Our ref: SO/2022/121922/04-L01
Your ref: 67946
Date: 15 June 2022

EMAIL DATED 24 MAY- REPLACEMENT OF MILLTOWN STREET FOOTBRIDGE WITH NEW FOOT/CYCLE BRIDGE. LAND ON THE SOUTHEAST SIDE OF, MILLTOWN STREET, RADCLIFFE.

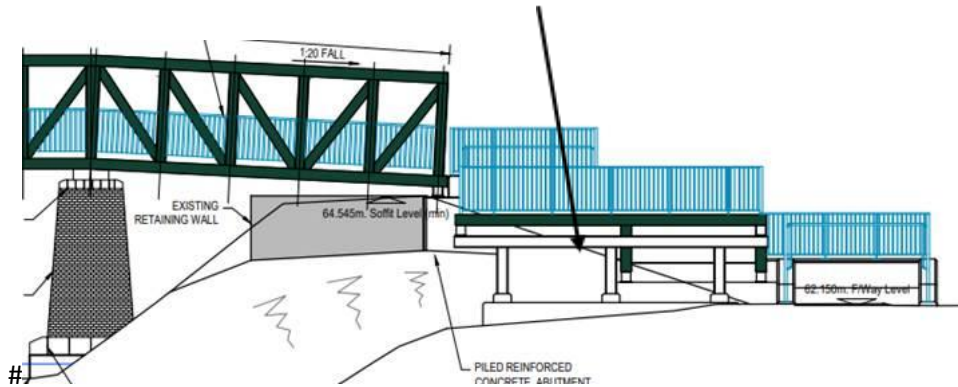
- As reflected on the attached drawing 660/024/002; an open access ramp of steel construction has been provided to the greater portion of the southern approach (see response to 'Item D' for further comments). **There needs to be adequate routes for overland flows to re-enter the watercourse. We need to ensure any bank raising provides routes for flows. (See screen shot)**

Clarification needs to be provided on how much backfilling will be done, and where the water can re-enter the watercourse.

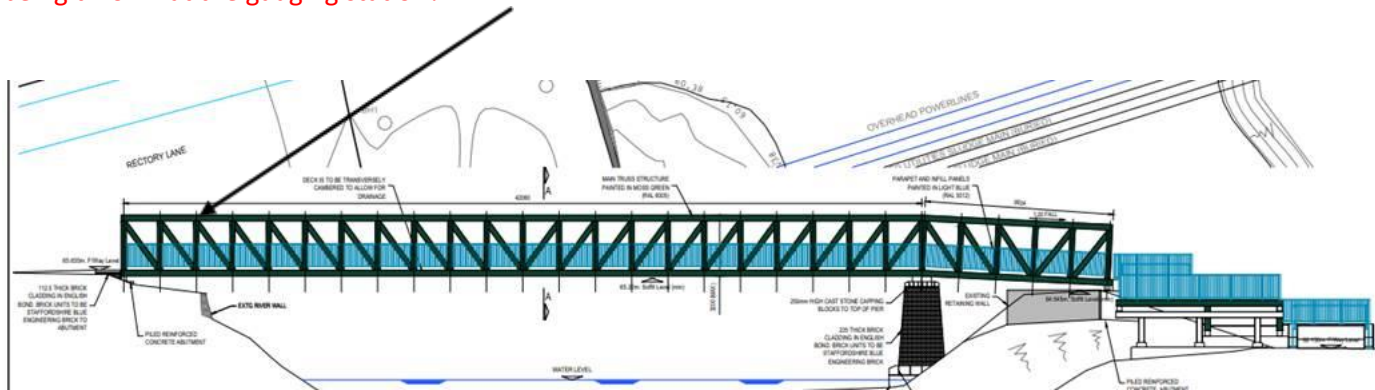
We were referring to items being thrown from the top of the bridge onto the top of our gauging station. With there, only being a waist height barrier from the bridge, items could have the potential to be thrown. Would it be possible to encapsulate the Rectory Lane side of the bridge to full height? See screen shot below. Would it be possible to raise the rail to full bridge height, to deter objects being thrown at the gauging station?

- The gauging station and surrounding palisade fence is indicated in the attached pictures. As can be seen, pedestrian access to the gauging station remains possible from Rectory Lane, which will remain unaffected by the proposed works. As part of the proposed bridge works there is no intention to remove Rectory Lane, although it will become largely redundant once the new access path is provided to the northern bridge abutment. It will also be written into the tender documents, that the appointed contractor will maintain access throughout the construction works.

- Regarding the potential for vandalism of the gauging station once the new bridge is constructed, it is noted that at its closest the palisade fence to the gauging station will be circa 6m away from the edge of the bridge, with a level difference of circa 3.5m from bridge deck to gauging station ground level. It is also noted that the existing palisade fencing

around the gauging station is only in the order of 1.8m high, with lower metal railing above the existing banking/retaining to the north. Given the above, it is not considered that provision of a new bridge, albeit at an elevated level, will significantly increase the potential for vandalism.
